802.3cu D1.1 PMD Spec Comments

P802.3cu 100 Gb/s and 400 Gb/s over SMF at
100 Gb/s per Wavelength Task Force Ad Hoc

11 December 2019

Chris Cole

TDECQ - $10\log_{10}(C_{eq})$ Jonathan King Analysis

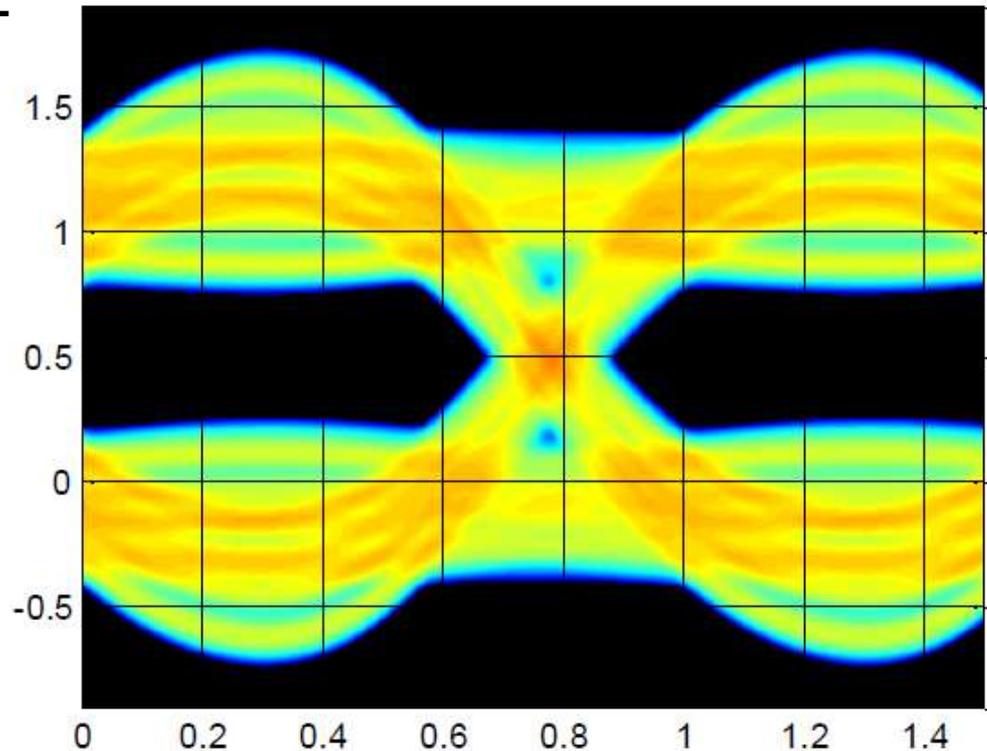
- “TDECQ- $10\log_{10}(C_{eq})$ is not a good indicator of how hard the EQ has to work, nor of it’s likely resilience to receiver impairments.”
- “The transmitter most likely to be affected by receiver non-linearity, quantization, or other sampling errors, is the TX with the most severe effective eye-closure out of the O/E”
 - severe TX eye closure \rightarrow RX $H_{eq}(f)$ is HPF vs. 4th B-T
 - TX eye closure up \rightarrow TDECQ - $10\log_{10}(C_{eq})$ down
 - TDECQ - $10\log_{10}(C_{eq})$ does the inverse of desired
- “There is no value in adding a TDECQ- $10\log_{10}(C_{eq})$ limit. Adding one unnecessarily limits the use of a tool (transmitter pre-emphasis) which can improve transmitter yield and cost, and link margins.”

TX Signal Historical Time Domain Spec Limits

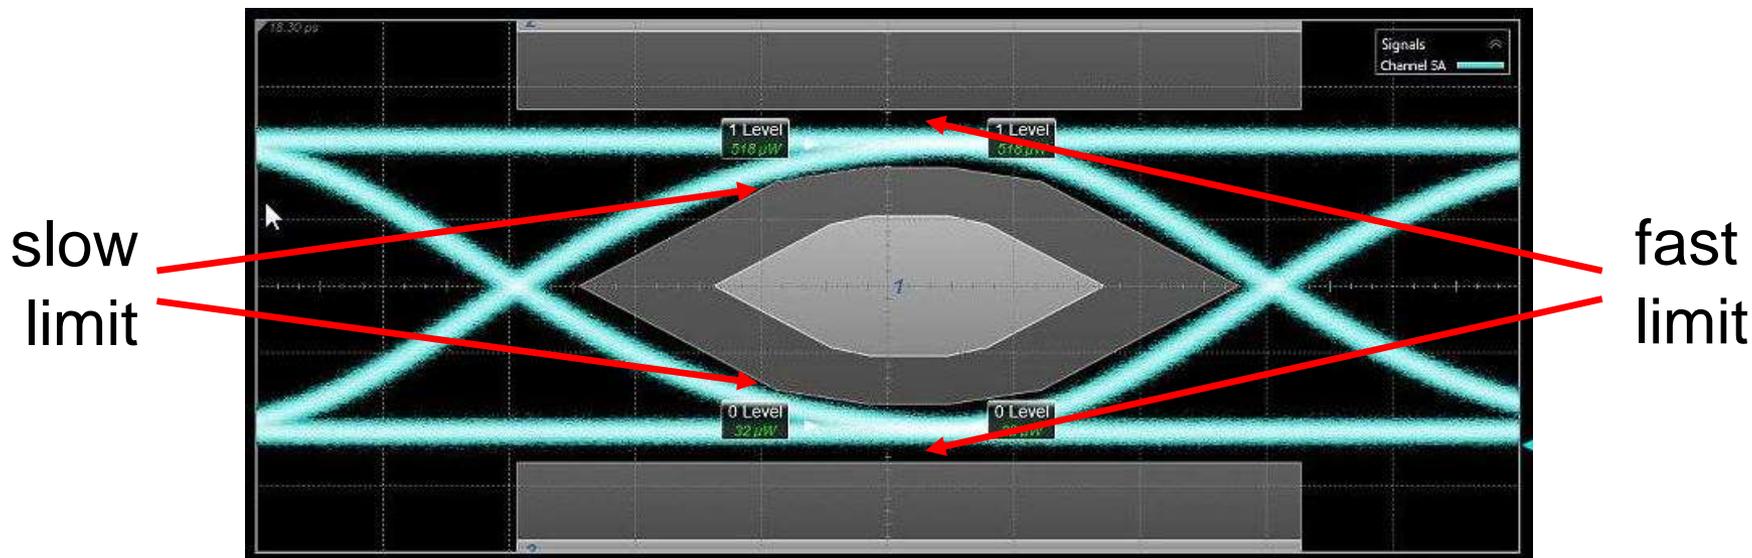
- Eye Mask (ex. 10G NRZ eye using Keysight DCA)

- Successfully used with BER spec limits for decades
- Requires open TX eye, which NRZ signals have
- Dropped as spec for PAM4 signals because the TX eye can be closed, yet still recoverable by an adaptive equalizer
- Simple solution: use NRZ signal for TX time domain tests

Mask Limit Jonathan King 2/15/19 Proposal

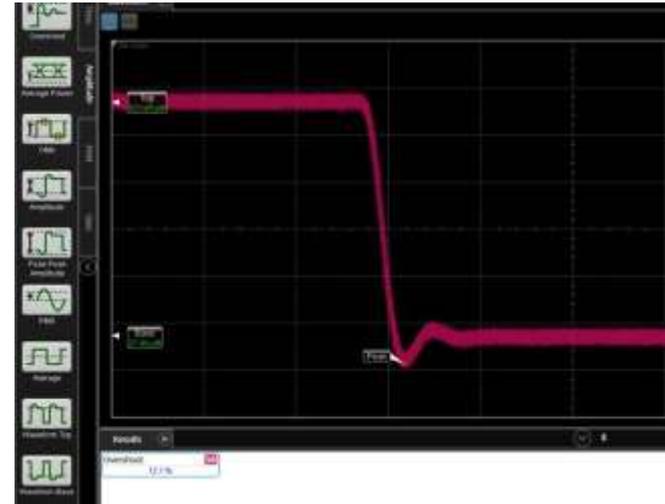
- Square wave is perfect for time domain basics
- Easy to generate and lock to
- Long stretch of “0s” and “1s” either side of each transition
- Direct TX measurement with short patch cord to the scope generating no significant timing wander
- Direct read out of over-shoot and under-shoot in OMA units
